Re: Structural Observation—24 West Landing, Sanford, NC 27332

BACK OFFICE WINDOW MODIFICATION

Picture 1 – 24 West Landing, Sanford, NC

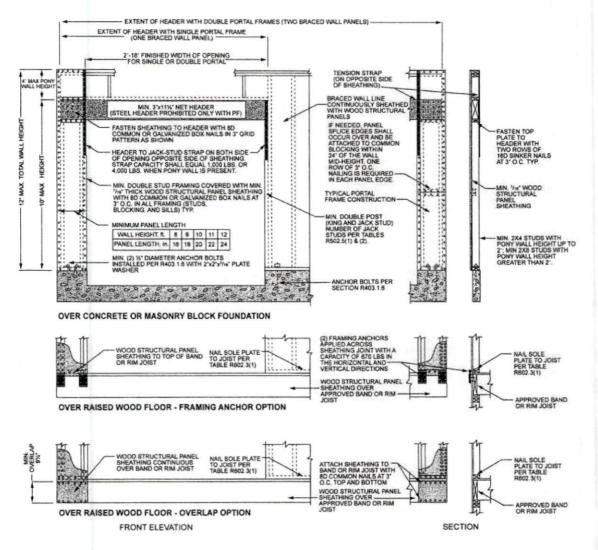
At your request, we analyzed the back office window opening that is proposed to be modified to accommodate a window and door combination at the Sanford residence noted above. Renovation drawings by Robert Mikesell dated 12/2/2005 were provided during a previous site visit. The structure is a conventionally framed, detached, single family residence with raised 1st floor framing over a pier/girder foundation system with perimeter masonry foundation walls (see picture 1).
